C1980007, West Elk Mine, MR-459, Initial Adequacy Review

Re: West Elk Mine (Permit No. C-1980-007)
Minor Revision No. 459, (MR-459)
Initial Adequacy Review

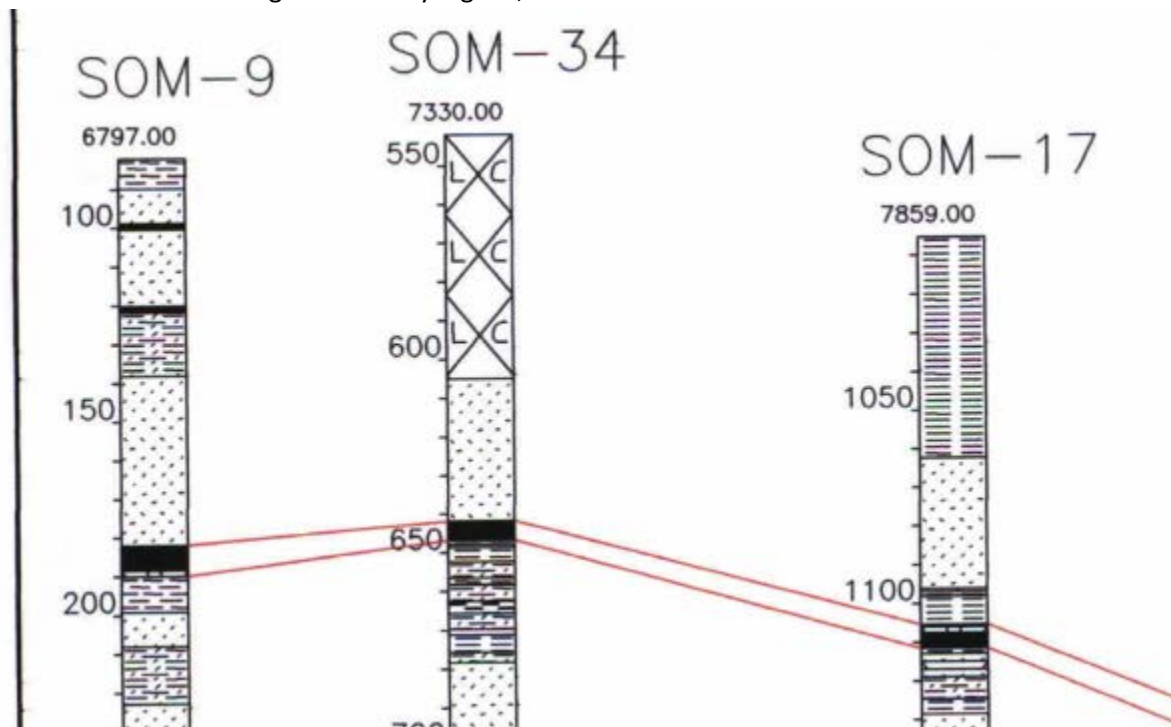
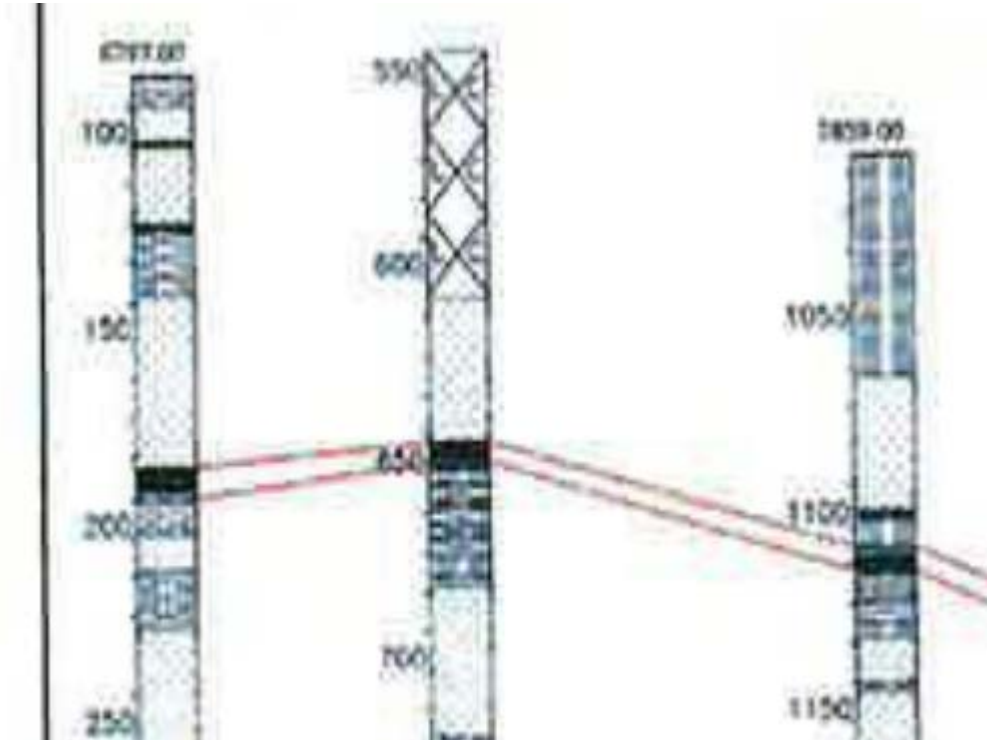
4. Figures 5A-F show stratigraphic cross sections. In order to be legible these figures need to be displayed on a large format page. In the currently approved PAP each figure is indexed separately, and printed on a 36x24 page. When displayed at 100% the information on the figure is clearly legible, as can be seen on the screen shot below:

On the proposed revised pages the same figures are included with the text, on regular 8.5x11.5 pages. When displayed at 100% the information in each figure is too small to be legible, as shown to the right.

If the figures are magnified, the resolution is such that the information is too blurred to be legible, as shown below:

Please remove figures 5A-F from the proposed revised text. These figures are easily found in the laserfiche database and should remain as stand-alone items in the PAP.
